**Re: SRSP-305.9 Issue 6, Technical Requirements for Fixed Line of-Sight Radio Systems Operating in the Band 5925-6425 MHz**

RABC has completed its review of the proposed draft revision of SRSP-305.9, Issue 6. Overall, RABC agrees with the latest version provided by the Department on April 11, 2019, which includes the removal of RF channel bandwidth below 5 MHz and addition of support for 60 MHz RF channel bandwidth.

**Proposed revised envelope B  
(to replace Table 7 and Figure 1 in latest draft of SRSP-305.9 provided in April by the Department)**

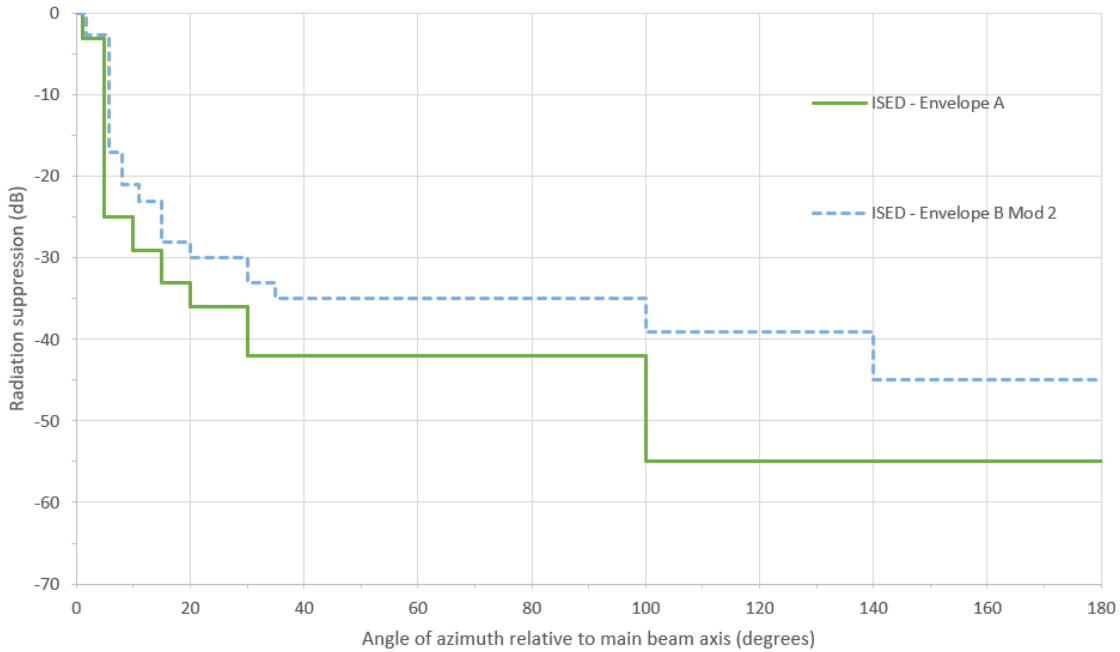
FS proponents are proposing replacing envelope B in Table 7 and Figure 1 of currently in-force SRSP-305.9 for outside of moderate and highly congested areas with the envelope B below. This would relax the current envelope B 1 to 4 dB over some angles between 5 and 35 degrees allowing the use of certain high performance 1.2 meter antennas, in addition to 1.8 meter antennas. The intent is to provide more flexibility in FS link deployment, with significant potential cost savings for FS operators and therefore facilitating the operation of FS networks. Following many discussions, it is the FS proponents' view that it will be very unlikely that a FS link using 1.2 meter antennas would receive more interference from future potential interferer (e.g. FSS earth stations, FS links, etc.), than if the FS link would have used 1.8 meter antennas complying with envelope B as specified in the current SRSP-305.9 (Issue 5).

As such, from the antenna perspective, the FS proponents' proposal is only to replace current envelope B with the one proposed in Annex 1. Consequently, the FS proponents consider the use of 1.2 meter antennas complying with the proposed revised envelope B as standard equipment as per SRSP-305.9.

FSS proponents agreed conditionally with the proposal by FS proponents to replace envelope B, in Table 7 and Figure 1 of currently in-force SRSP-305.9 for outside of moderate and highly congested areas, with a proposed new envelope B. The new envelope B would be relaxed by up to 4 dB, as stated by the FS proponents, over some angles between 5 and 35 degrees, allowing the use of the proposed 1.2 meter antennas (as the characteristics are given above), in addition to 1.8 meter antennas, when it is possible. As mentioned a number of times during the working group meetings, both FS proponents and FSS proponents have agreed that the proposed 1.2 meter antenna mask would provide more flexibility in FS links deployment, potentially saving significant amount of cost for FS operators and therefore facilitating the operation of FS networks. As a result, FSS proponents can agree to this approach with the requirement that these advantages for FS operators should not be at the expense of FSS community, as it is further explained below.

Specifically, there is a foreseen potential issue in the case of a new FSS earth station that could be deployed in the area where a FS link would already be in service using the proposed 1.2 meter antennas as per relaxed envelope B mentioned above (see the characteristics of the proposed 1.2 meter antenna envelope above). While the value of the interference received by a FS 1.2 meter antenna might be unchanged compared to a FS 1.8 meter antenna according to FS proponents, the value of the wanted signal received by 1.2 meter antennas (that have less gain by at least 3.5 dB than 1.8 meter antennas) would be reduced by at least 3.5 dB compared with if 1.8 meter antennas had been used. This is the reason that the FSS proponents have suggested the addition of the “note” given below to the revised SRSP 305.9, in case the Department decides to proceed with the revision.

The discussions led to possible cases that a FS link using the proposed 1.2 meter antennas with relaxed envelope B mentioned above could receive lower signal –to - interference ratio from a new FSS earth station than if the FS link would have used 1.8 meters antennas complying with the currently in-force SRSP-305.9. The FSS proponents noted that the FS proponents have stated that in effect the above impact would be unlikely. FSS proponents have proposed to insert the following “note” in relevant section (e.g., in section 7, but immediately after the new proposed relaxed antenna mask) of the revised SRSP-305.9 (issue 6). The added note given below will address this potential issue:

“In case of future deployment of FSS earth stations, if the signal-to-interference level of any 1.2 meter FS antenna , complying with Envelope B in issue 6 of this SRSP, is less than signal – to – interference level that would have been received as a result of using a 1.8 meter antenna complying with Envelope B in issue 5 of SRSP-305.9, and in cases it triggers a coordination process, the FS operator using the 1.2 meter antenna has the option to move up to the 1.8 meters antenna or accept the potential signal degradation, if any.”
